Committee of Experts on the Transport of Dangerous Goods and on the Globally Harmonized System of Classification and Labelling of Chemicals

Improvement of test series 8

Response to informal document UN/SCETDG/62/INF.10

Transmitted by the Institute of Makers of Explosives (IME)

Figure 1. Schematic of a road tanker and the NATO Fast-heating test pipe

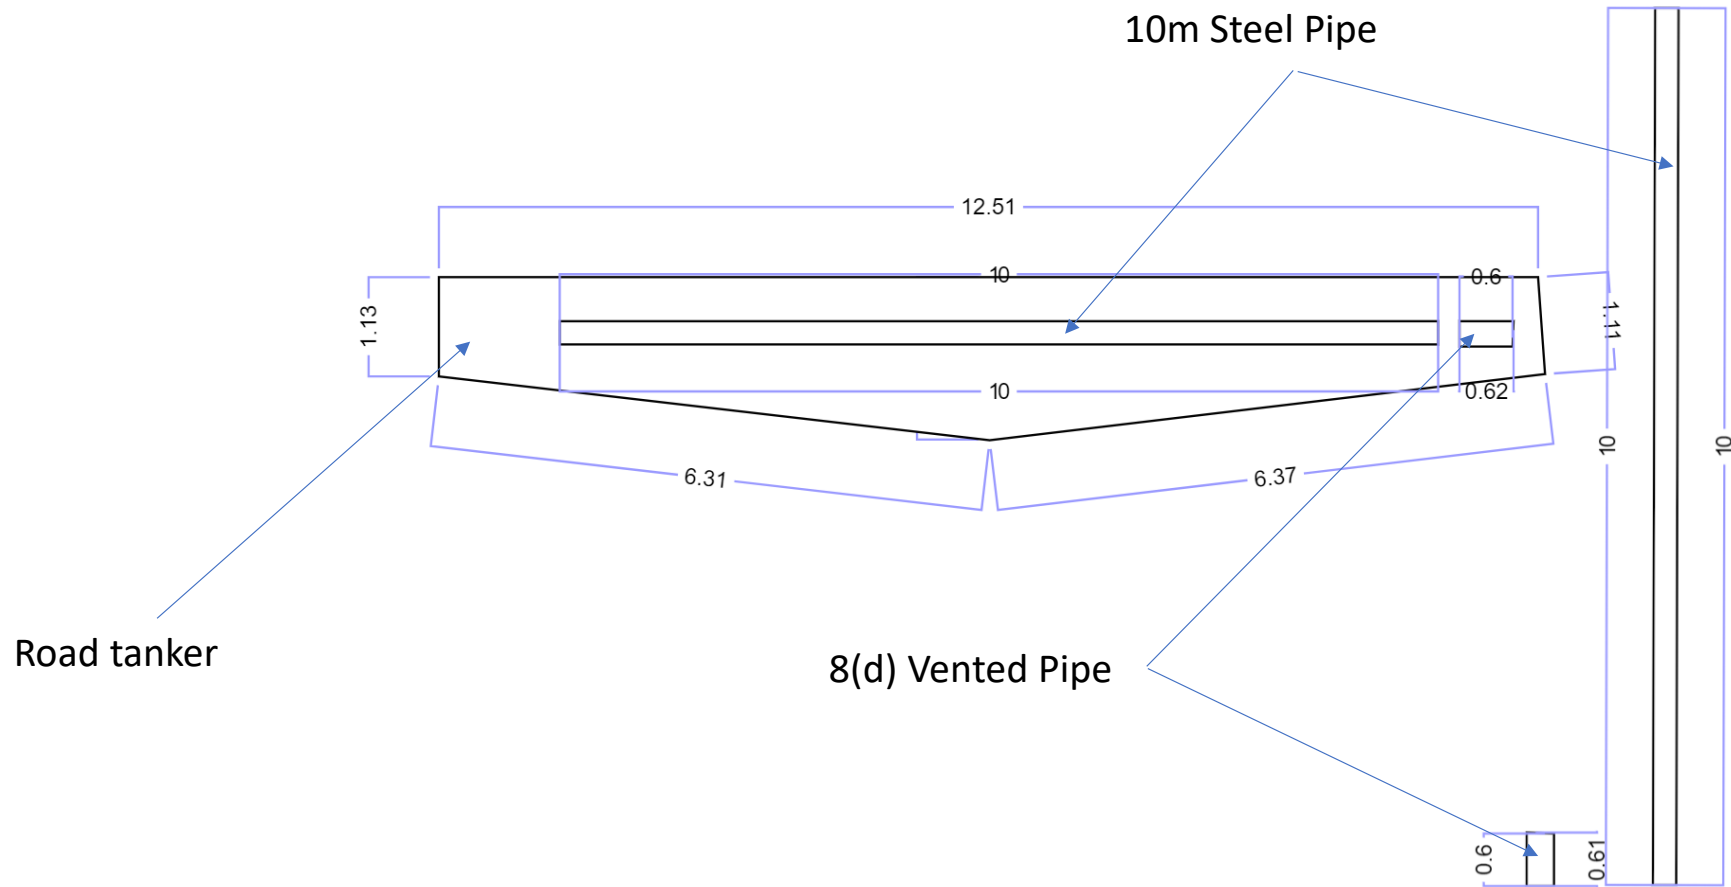
11. In informal document UN/SCETDG/61/INF.43, it was identified that the research presented in informal document UN/SCETDG/60/INF.42 was intended to study the behaviour of an ANE in blastholes under extreme heating. The configuration used in the fast-heating munitions test in SCETDG/62/INF.10 is identical to that used in informal document UN/SCETDG/60/INF.42 and is thus similar to that of a blasthole rather than a road tanker. An illustration of the 10 m steel tube compared to a road tanker is given in Figure 1.

12. The fast cook-off test setup (Figure 1 in informal document SCETDG/60/INF.42) is a long cylindrical pipe in a vertical orientation. Consequentially, the driving force for buoyant convection is several orders of magnitude larger in this experimental setup than would be seen in a tanker. This is due to the modified Rayleigh number effects. The Rayleigh number is the ratio of the characteristic buoyancy-driven convective heat transfer to thermal diffusion and is directly proportional to the length scale in the direction of gravity to the fourth order. Since the long cylindrical pipe is one order of magnitude larger than the radius of the tank modelled in the simulations, the convective heat transfer is 1×10^4 larger than thermal diffusion.
